# TCIEVMK2LX Known Issues

SR No#	Issue Detail	Effected Board Version No.	Resolved Board Version No.
1	<a href="#">JESD pins swap issue</a>	EVM v 1.0.1.1 EVM v 1.0.2.0 EVM v 1.0.2.1	EVM v 1.0.3.0
2	<a href="#">10MHz clock validation test issue</a>	EVM v 1.0.1.1 EVM v 1.0.2.0 EVM v 1.0.2.1	EVM v 1.0.3.0
3	<a href="#">LM10011 Enable pin pull up resistor (R524) value</a>	EVM v 1.0.1.1 EVM v 1.0.2.0 EVM v 1.0.2.1	EVM v 1.0.3.0
4	<a href="#">LMK programming failure issue</a>	EVM v 1.0.1.1 EVM v 1.0.2.0 EVM v 1.0.2.1	EVM v 1.0.3.0
5	<a href="#">CVDD1 nominal voltage implementation as per the latest K2L datasheet revised Oct-2014</a>	EVM v 1.0.1.1 EVM v 1.0.2.0 EVM v 1.0.2.1 EVM v 1.0.3.0	EVM v 1.0.3.0
6	<a href="#">SOC Power Failure issue</a>	All	
7	<a href="#">XDS200 firmware issue</a>	All

## 1. JESD TX lanes 1 and 2 swapping issue

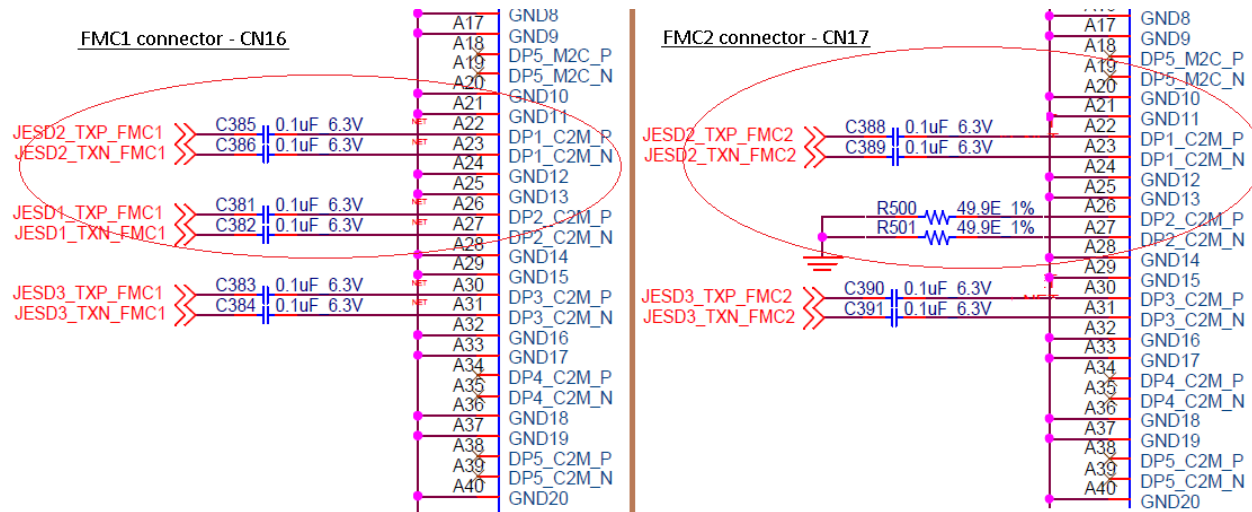
In Alpha (V01) and Beta (V02) version of K2L EVMs, JESD TX1 and TX2 routing is as shown below picture. This is different from FMC standard pin mapping.

This issue shall be resolved from EVM v1.0.3.0 and onwards.

CN16 (FMC1 connector)			
Pin no	Pin name	Current Implementation	As per FMC standard
A22	DP1_C2M_P	JESD2_TXP_FMC1	JESD1_TXP_FMC1
A23	DP1_C2M_N	JESD2_TXN_FMC1	JESD1_TXN_FMC1
A26	DP2_C2M_P	JESD1_TXP_FMC1	JESD2_TXP_FMC1
A27	DP2_C2M_N	JESD1_TXN_FMC1	JESD2_TXN_FMC1

CN17 (FMC2 connector)			
Pin no	Pin name	Current Implementation	As per FMC standard
A22	DP1_C2M_P	JESD2_TXP_FMC2	GND (Not used)
A23	DP1_C2M_N	JESD2_TXN_FMC2	GND (Not used)
A26	DP2_C2M_P	GND	JESD2_TXP_FMC2
A27	DP2_C2M_N	GND	JESD2_TXN_FMC2

To resolve this JESD swizzle issue on board (V01 and V02), use TI's latest RFSDK.

### 5. CVDD1 nominal voltage implementation as per the latest K2L datasheet revised Oct-2014

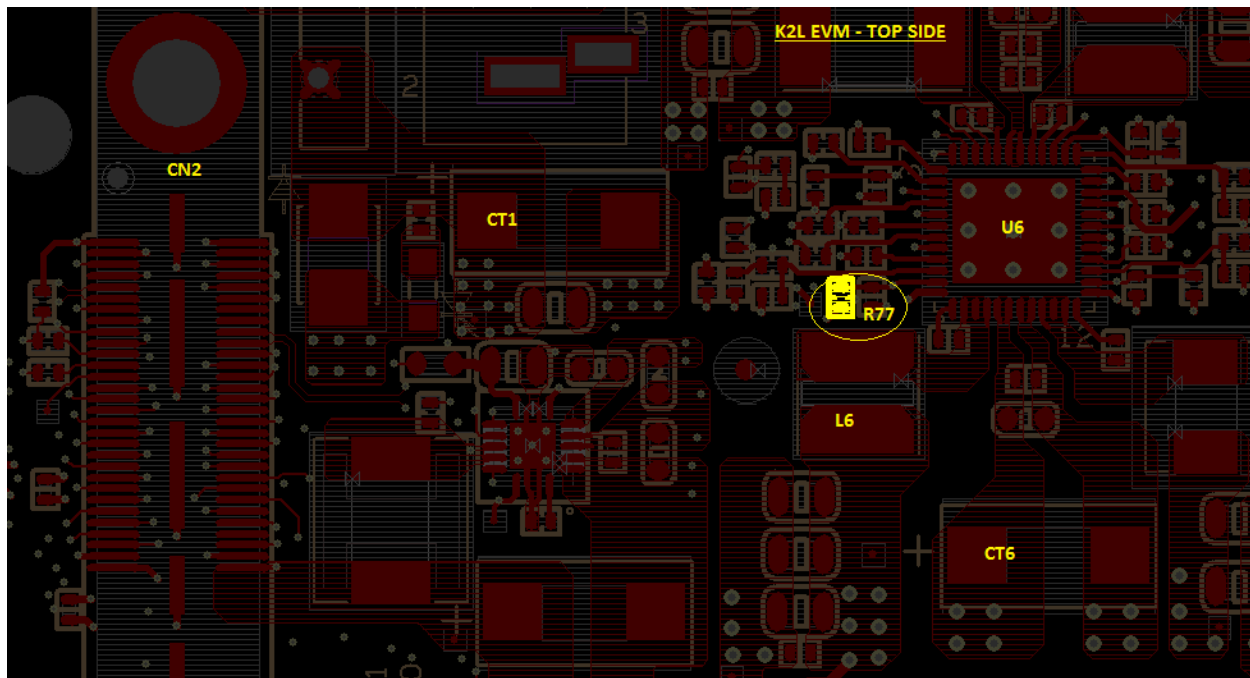
To resolve this issue on V01, V02 and V03 boards, remove 10.2Kohm resistor from R77 location and mount 7.68Kohm resistor. Refer below picture to identify the location of R77.
